# SERVICE INFORMATION

## STANDARD AND TRIUMPH VEHICLES

<b>No.</b>	SPORTS/2/B	EXCESSIVE LOSS OF OIL FROM THE CRANCASE BREATHER PIPE	<b>Date</b>	APRIL 1954
------------	------------	--	-------------	------------

1 ILLUSTRATION.

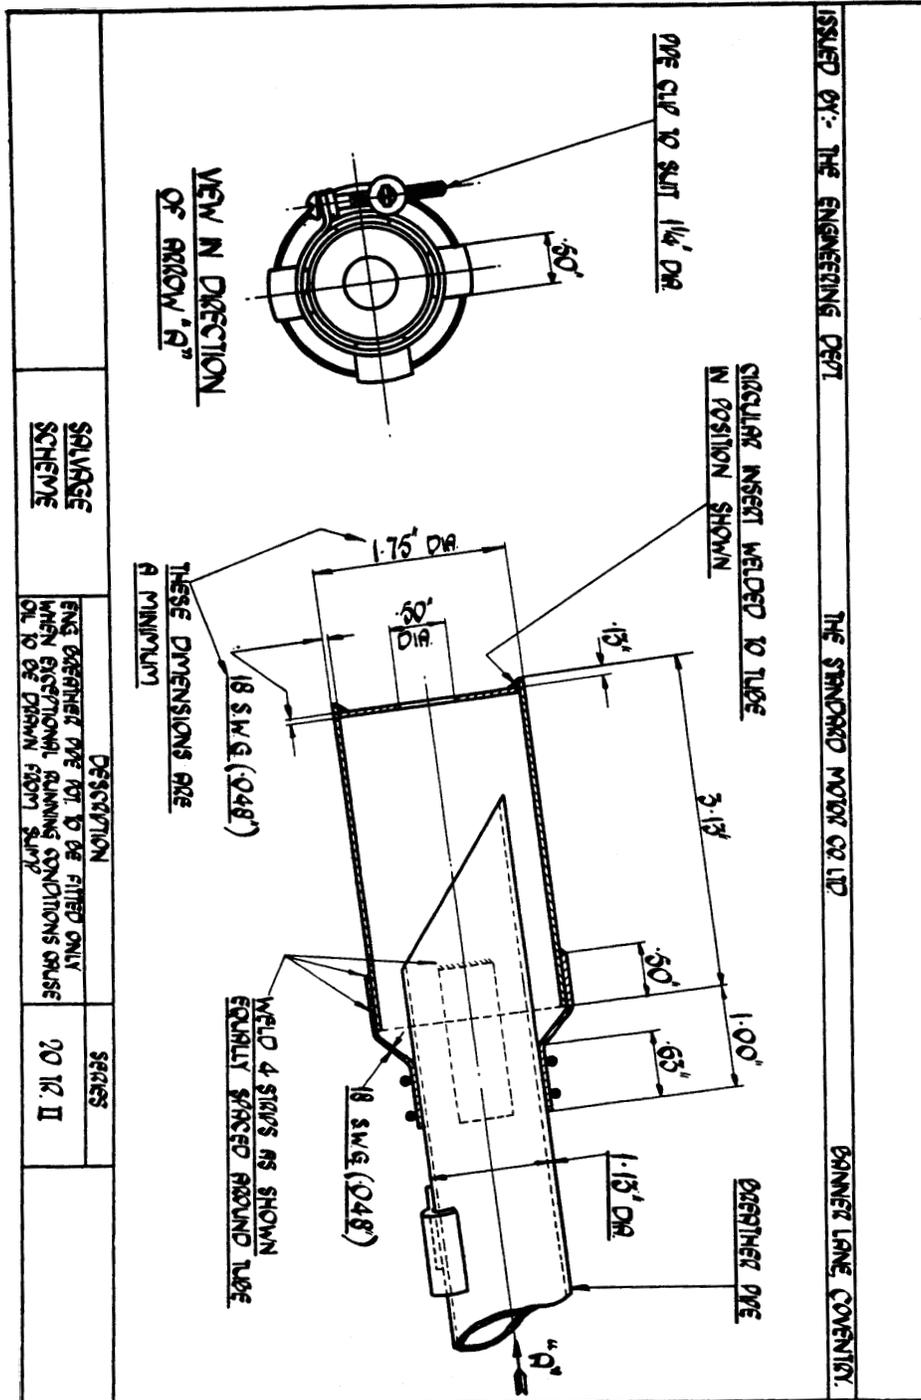
It has been found that under sustained top speed condition that the oil splash in certain engines allows considerable loss of oil through the crankcase breather pipe, Part No. 201650.

The crankcase was modified at Commission No. TS.972E. to incorporate in the casting a baffle to shield the breather pipe aperture. A new breather pipe, Part No. 202126., must be used with the modified crankcase.

To deal with complaints of excessive loss of oil at this point, with cars prior to the Commission Number quoted, the end shield shown in the illustration can be quite easily fabricated and fitted.
